**TO:** Design Review Commission  
**FROM:** Sierra Davis, Assistant Planner  
**SUBJECT:** 16-SC-24 – 300 Cuesta Drive

Approve design review application 16-SC-24 subject to the listed findings and conditions

This is a design review application for a new two-story house. The project includes 2,506 square feet on the first story and 1,381 square feet on the second story. The following table summarizes the project's technical details:

Oak #1 profile

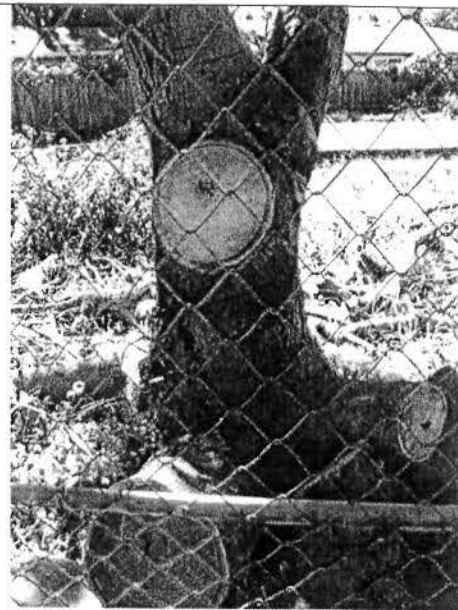
Pruning cuts visible in oak #1

Oak #1 pruning cut close-up view.

Oak #2 large diameter pruning cut.

Canopy view of oak #2, showing some moderately large diameter pruning cuts on scaffold limbs.

Oak #1: No actions necessary.

Oak #2: Retain an ISA Certified Arborist to prune out stubs remaining on sections of the tree that were recently pruned. Pruning can occur any time, within the next three months.

Center of image: oak #3 lower area.

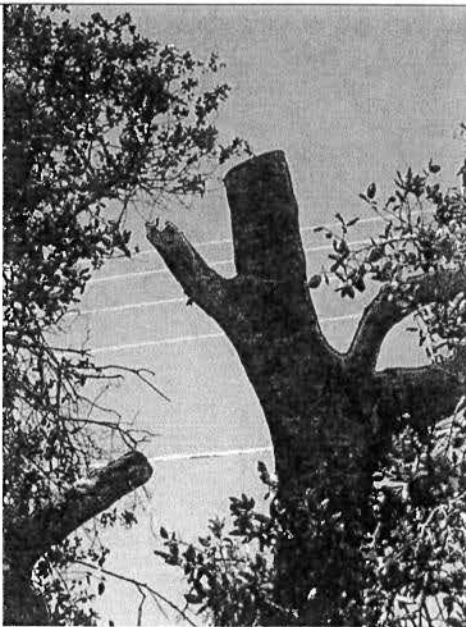
Upper canopy area of oak #3's remaining above ground biomass, showing the topping cuts that were made throughout the entire canopy. The tree will have to be managed by a very good pruner over time to periodically prune selected sprouts arising from near the cut areas, to restructure a new canopy by using those selected sprouts to form a "new canopy".

An eight inch diameter limb on oak #3 that sustained a six foot long (approx.) stripped out area where bark peeled off from the pruning cut as the cut portion of the limb fell. This area will have to be removed.

Close-up of another stripped bark area on a smaller diameter stem on oak #3 (center of image) that will have to be removed to avoid tissue dieback.

- a. Feb/March/April 2016: Time Period: Retain an ISA Certified Arborist to perform restoration pruning of the tree in 2016 to remove stripped out stem sections, stubs, etc. and restructure the entire tree as needed. This pruning can occur any time within the next three months (Feb, March, April 2016).

- b. March/April 2016: Have Advanced Tree Care or another fertilization provider perform "injection fertilization" of the entire root zone of oak #3 using Romeo Packing Company's "Greenbelt 22-14-14" soluble tree formula fertilizer with micronutrients at standard mixing rate and injection volumes.

- c. June 2016: Keep the tree well irrigated throughout 2016 by performing 1x/month heavy soaking at approximately 15 to 20 feet radius out from trunk. Do not irrigate within 15 feet of trunk if possible. Irrigation should commence approximately June 2016.

- d. After Pruning / Root Zone Protection: Avoid root zone damages by erecting chain link fencing pruning as far out as possible from the trunk (e.g. 12 to 20 feet radius) from trunk, after first applying a wood chip mulch to the soil surface.

- e. After Pruning / Woodchips: Apply a 4 inch thick layer of coarse chipper truck-type wood material chips (not bark chips or shredded redwood bark) to the entire surface of the root zone area that will be fenced off (e.g. 30 foot diameter circular area, etc.). This material is available for pickup in truckloads by the cubic yard, at landscape material supply houses such as Lyngso of Redwood City.

- f. Follow-up Pruning: Retain the same arborist to perform a follow-up pruning session in 2017 to manage sprouts arising from the canopy. Restorative pruning may require subsequent restoration pruning sessions for a number of years (e.g. 4 to 5 years, etc.) in order to carefully manage newly arising sprouts that will become the new canopy of this tree. This pruning can be performed at any time of the year, but preferably in winter.
